Access Compliance Report

Public Rights-of-Way

(Curb Ramps)

Intersection ID: 5199	Main Street: N_TRYON_ST	Cross Street: BARTON_CREEK_DR	Location: NW
ADA ID: 617573942AFC	Ramp Type: Directional1	Initial Pass/Fail: Fail	Overall Compliance: No
Severity Score: 1.25			
Codes/Mitigation Info/Possible Solution		Field Measurements/Component Compliance

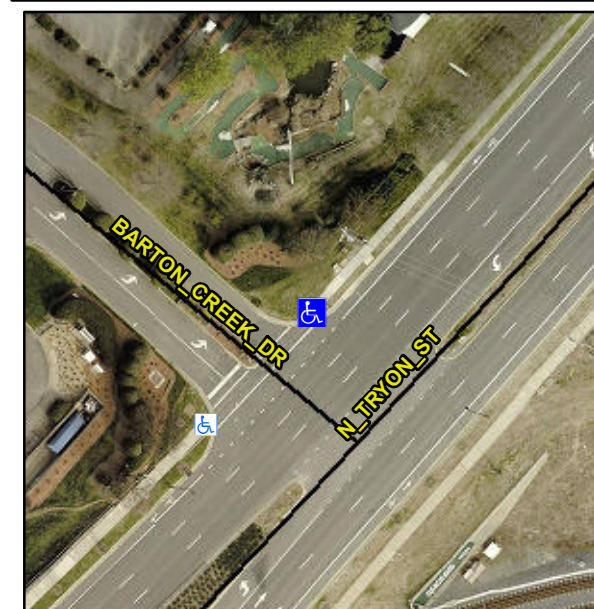
R304.5.3

Compliance	Description	Data	Compliance	Description	Data
N/A	Ramp Length (in)	82.0	N/A	Grade Break?	N/A
Yes	Ramp Width (in)	54.0	N/A	Grade Break Slope (%)	0.0
Yes	Ramp Slope (%)	6.4	N/A	Grade Break XSlope (%)	0.0
No	Ramp XSlope (%)	2.2			
N/A	Flare Type LT	N/A	N/A	Flare Type RT	N/A
N/A	Flare Slope LT (%)	N/A	N/A	Flare Slope RT (%)	0.0
N/A	Flare Traversable LT?	N/A	N/A	Flare Traversable RT?	N/A
N/A	Landing Length (in)	0.0	N/A	DWS Provided?	N/A
N/A	Landing Width (in)	0.0	N/A	DWS Contrast?	N/A
N/A	Landing Slope (%)	0.0	N/A	DWS Length (in)	N/A
N/A	Landing X Slope (%)	0.0	N/A	DWS Full Width?	N/A
N/A	Landing Curb? (Y/N)	N/A	N/A	DWS Offset LT (in)	N/A
N/A	Shared Landing?	N/A	N/A	DWS Offset RT (in)	N/A
N/A	Gutter Ponding?	0.0	N/A	Gutter Slope (%)	N/A
N/A	Gutter Lip Ht (in)	0.0	N/A	Gutter X Slope (%)	N/A
N/A	Painted X Walk1?	No		Road Slope (%)	3.4
	X Walk 1 Direction	To SW		Road X Slope (%)	4.8
	X Walk 1 Width (in)	N/A		Clear Space?	N/A

Remove & Replace Entire Ramp.
